COUNCIL ASSESSMENT REPORT NORTHERN REGIONAL PLANNING PANEL

PANEL REFERENCE & DA NUMBER	PPSNTH-172 – DA 22/0408
PROPOSAL	Construction of residential flat buildings comprising 78 residential apartments comprising of 3 x 4 storey buildings and 1 x 2 storey building with a common basement
ADDRESS	Lot 46 DP 1264557 – No 6 Grand Parade Casuarina
APPLICANT	Town Planning Alliance (NSW)
OWNER	Azure Project 35 Pty Ltd
DA LODGEMENT DATE	7 July 2022
APPLICATION TYPE	Development Application
REGIONALLY SIGNIFICANT CRITERIA	Clause 2, Schedule 6 of <i>State Environmental Planning Policy (Planning Systems) 2021</i> : Development that has a capital investment value of more than \$30 million.
CIV	\$66,575,000.00 (excluding GST)
CLAUSE 4.6 REQUESTS	N/A
KEY SEPP/LEP	SEPP 65 (ADG) and Tweed LEP 2014
TOTAL & UNIQUE SUBMISSIONS & ISSUES	Seven (7) submissions (objections)
DOCUMENTS SUBMITTED FOR CONSIDERATION	<p><i>Additional information provided in respond to Record of Deferral</i></p> <ul style="list-style-type: none"> • Architectural plan set dated 15 December 2023 • Record of Deferral prepared by Town Planning Alliance dated 22 December 2022 • Civil Plans • Design Verification Statement • Environmenta

Figure 4 North elevation of Building D - Previous plans (left) and current plans (right)

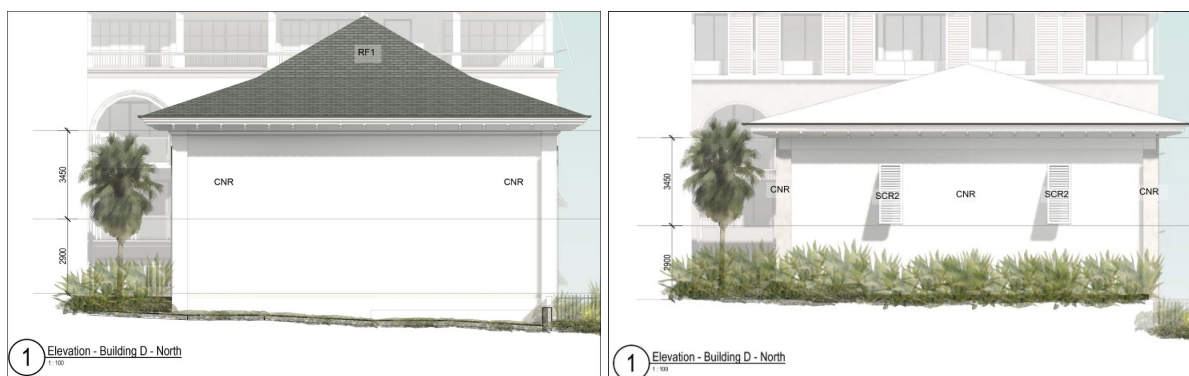
- The previous north and south blank elevations of the Building D now include additional vertical windows to bedrooms to the second level with white metal shutters as shown in Figure 4 below.

Figure 6 Deep soil zone provision - Previous plans (top) and current plans (bottom)

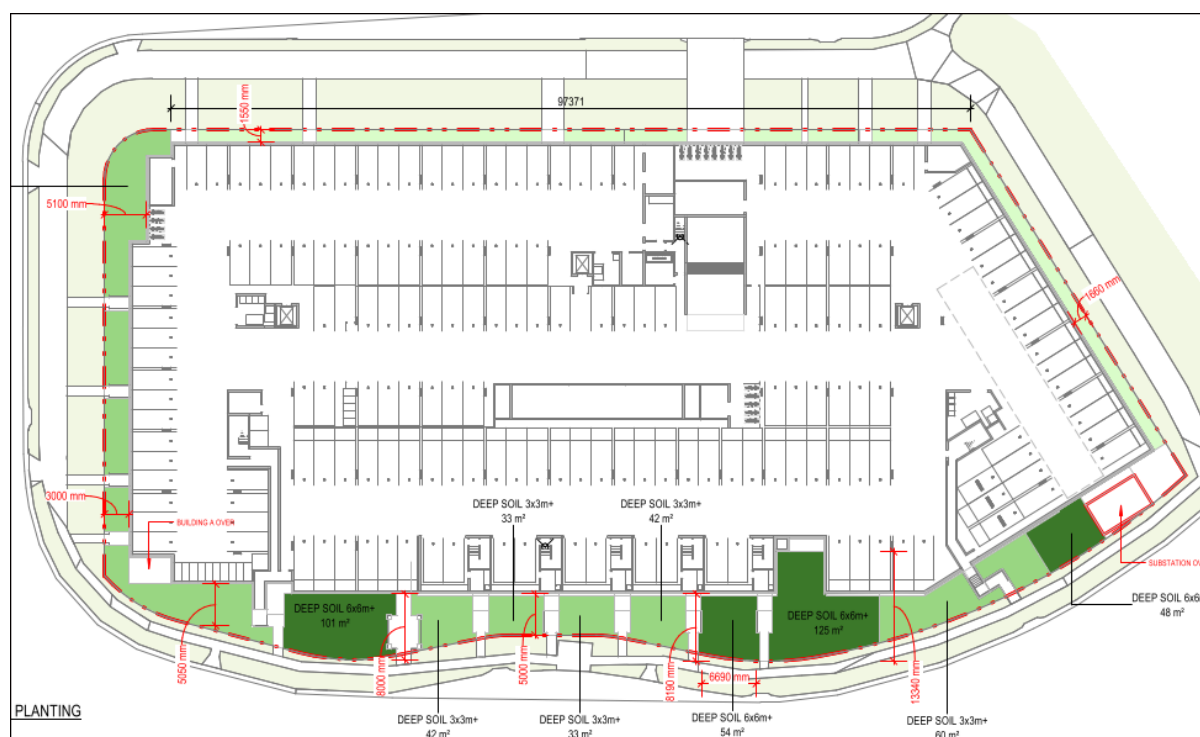
- The area of deep soil zones has increased by removing some areas of the basement parking level to provide additional areas for deep planting. The change is illustrated in Figure 6 and the table below (as reported in the plans):

Minimum Dimension	Area m ²	Percentage (%) of site area (7,354m ²)
Less than 3m	187	2.5%
3m – 6m	468	6.4%
Greater than 6m	537	7.3%
Total	1192	16.2%

Figure 10 Details of clerestory window openings Drawing No. DA 323 Revision 3 dated 19 February 2024

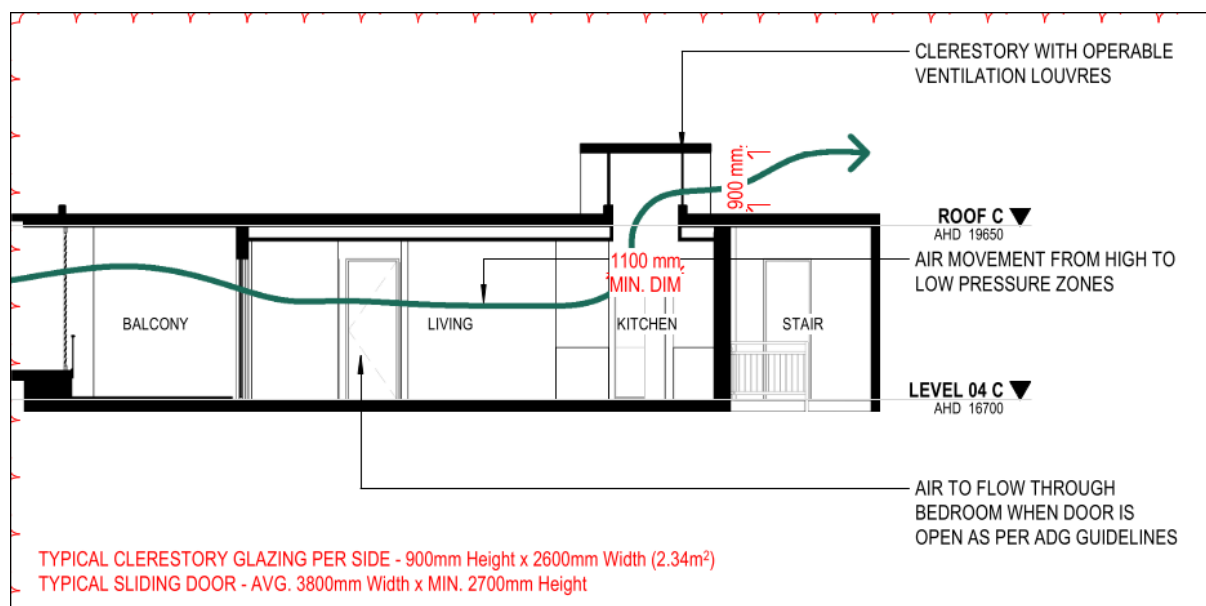
- *The two operable vertical sides at the rooftop rectangular clerestory windows are on perpendicular adjacent surfaces (DA 105 drawing) so that the owner can choose the more negative pressure side (for example).*

- *The size of the operable clerestory windows should be maximized within the other architectural design constraints. The flow area of the entry and exit building envelope penetrations (balcony doors and clerestory windows) should not be significantly mismatched (as suggested in SEPP65) - for example, an open, or partially open, balcony door (an operational owner choice) and the clerestory windows would all have openings of at least two square metres. In the case of the clerestory windows the operable louvres on the two perpendicular sides should both comply with this approximate two-square-metres suggestion, to allow for a wind azimuth operability choice by the owner.*

The plans have been amended to provide further details to demonstrate compliance with the recommendations above.

Figure 12 Approximate area of DSZ with a minimum dimension of 6m and clear of overhangs

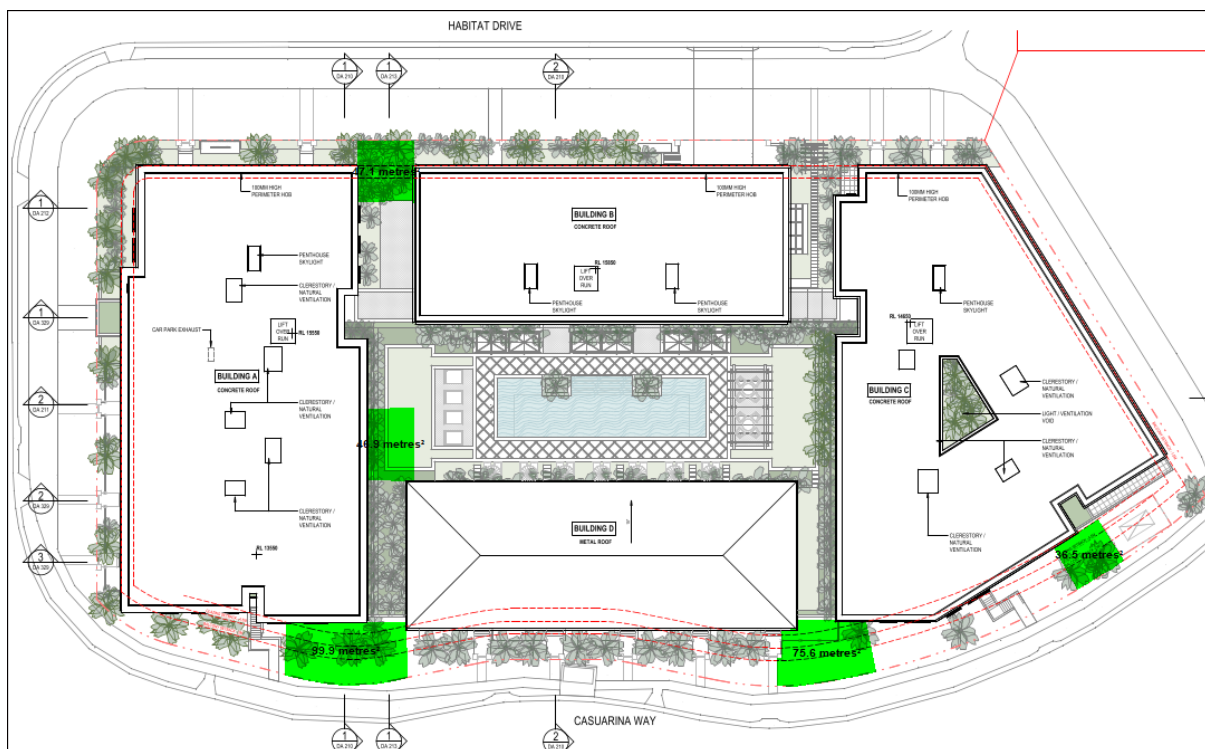
Building D includes eaves approximately 1.2m deep on all sides which are approximately 7.6m above natural ground level. This reduces the area of DSZ available for planting of large trees (over 7.6m in height) by approximately 200m² noting that the areas previously counted between Buildings A & D and Building D & C no longer meet the minimum 6m width due to the eaves of Building D. Area of DSZ clear of overhangs therefore is reduced to approximately 336m² or 4.6% of site area.

Figure 13 Excerpt from Landscape Plan – Sections -Sheet 3 DA-L-9052 (Revision 8) prepared by Laud Ink and dated 15 December 2023.

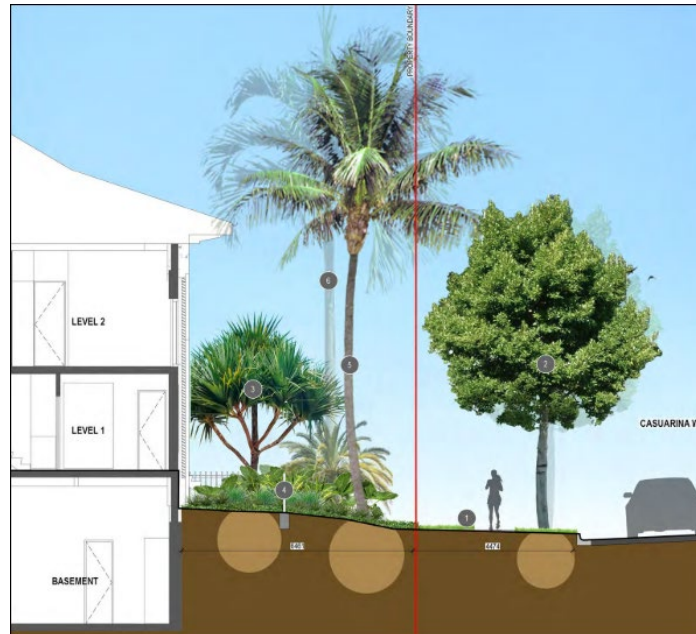
However, as shown on by the Landscape Plan – Sections -Sheet 3 DA-L-9052 (Revision 8) prepared by Laud Ink and dated 15 December 2023, trees with a height at maturity of greater than 7.6m (the height of the eaves Building D) would not be planted within 1.5m of the building footprint.

Accordingly, the amended plans are considered satisfactory with regard to the provision of DSZ and compliance with Design Criteria in Part 3E.

Figure 15 Interfacing windows of Building B to Buildings A and C for Level 4

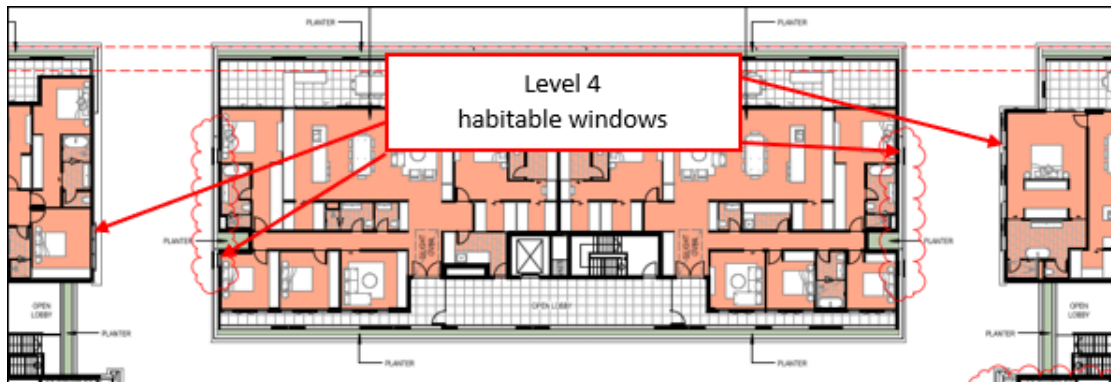
The amended plans now show openings to north and south elevation of Building B as previously detailed in this report. The openings on Levels 2 & 3 of Building B are to a laundry (non-habitable room) (refer to Fig. 14). The openings on Level 4 are narrow vertical windows to bedrooms with external shutters. These windows are secondary windows and are not the primary source of natural ventilation or light.

No changes have been made to the physical separation distances of the various buildings. As such, measures to address visual amenity impacts from blank wall has resulted in non-compliances with building separation criteria.

Visual connection between the windows of Building B where they interface with Buildings A and C is mitigated by the inclusion of shutters to each of the elevation as shown in Figure 5 in an earlier section of this document.
